FINAL PLAT LOT 1, BLOCK 1 CROSSINGS ADDITION

SITE PLAN		DATE 12/1/90	
HIGHWAY 205		T. WALTERS	
ROCKWALL, TEXAS		R212P000 DWG. ROTATED 60°00'	
SCALE 1"= 20'		JOB NUMBER 0	
SITE		REV.	
P1		0	
4-11111111 02

RACETRAC SITE PLAN - SH 205 NORTH OF IH-30 AND LAKESIDE CHEVROLET

Agenda Item: P&Z 91-1-CUP/SP/FP - Hold Public Hearing and Consider Recommending Approval of a Request From Racetrac, Inc., for a Conditional use Permit for a Building Not Meeting Materials Requirements and Approval of a Site Plan and Final Plat for a Self Serve Gas Station Located on SH-205 North of I-30

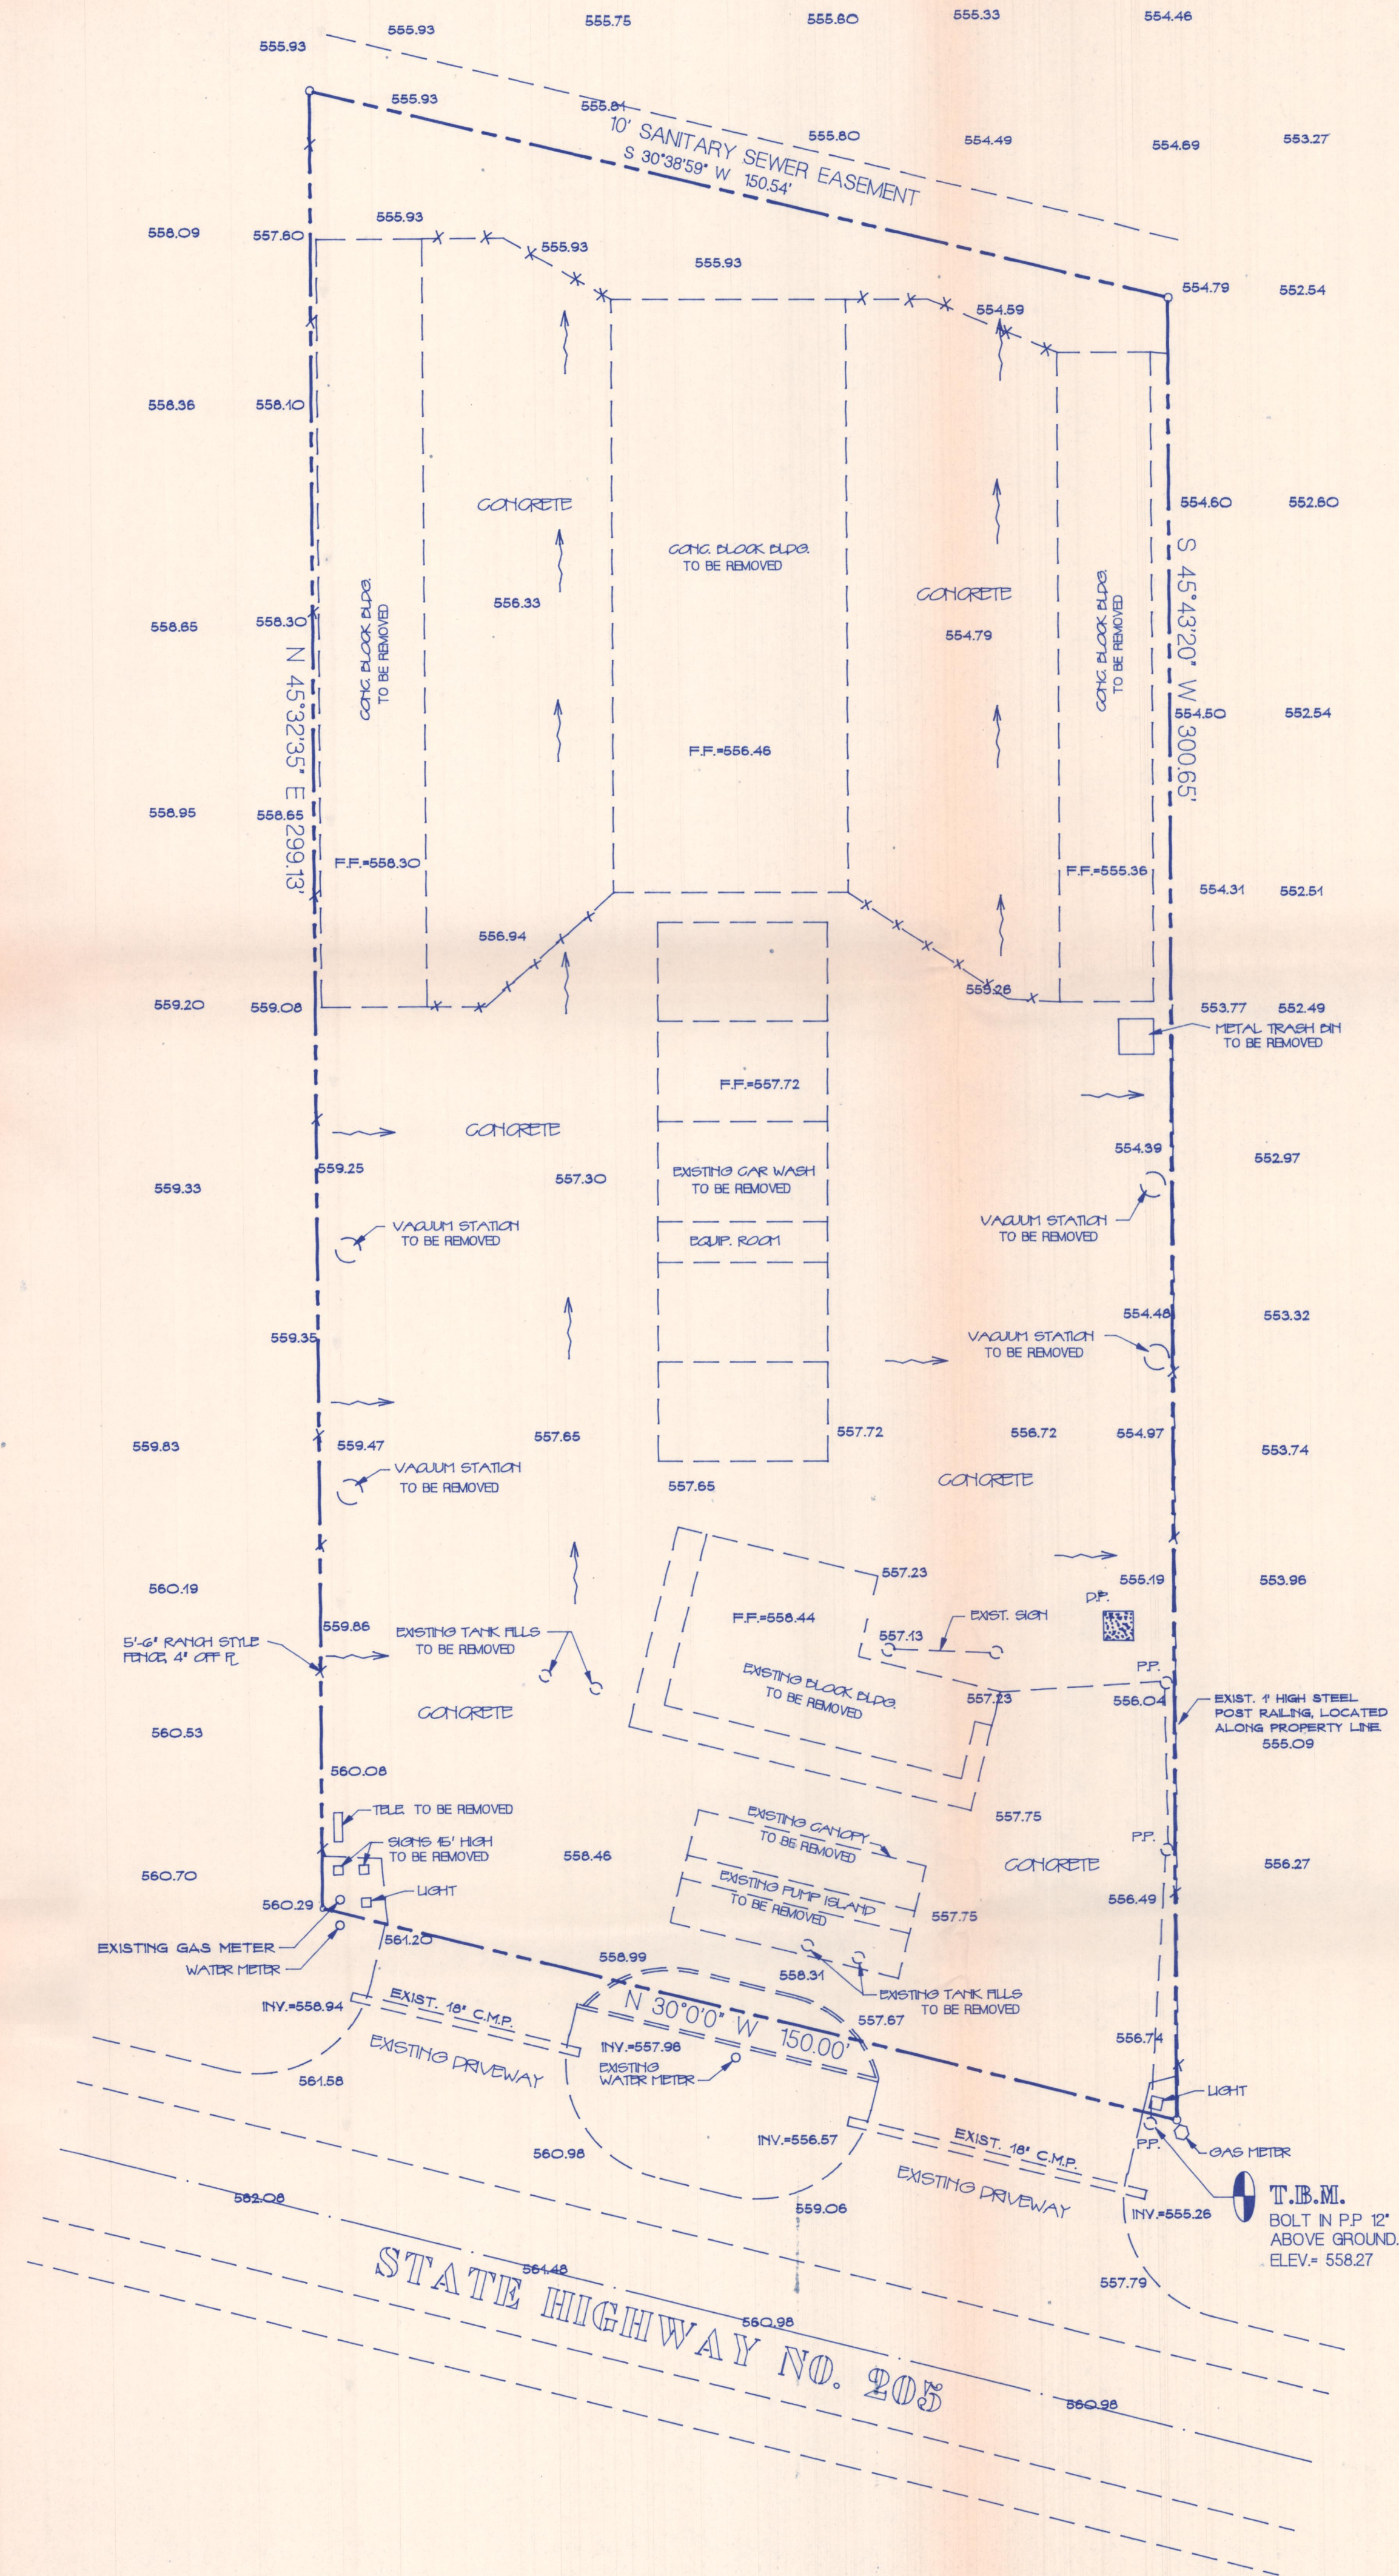
The property is not platted and they must complete that process in order to build. The plat meets our requirements with the exception of no faccess easment to the rear of the property and the inclusion of a utility easement along the frontage. They will provide this Thursday night.

The Commission recommended approval of the plat with the condition that a utility easement be dedicated along the front property line and that a 24 foot ingress and egress easement be provided along the south property line. They have added these items to the plat and a copy is attached.
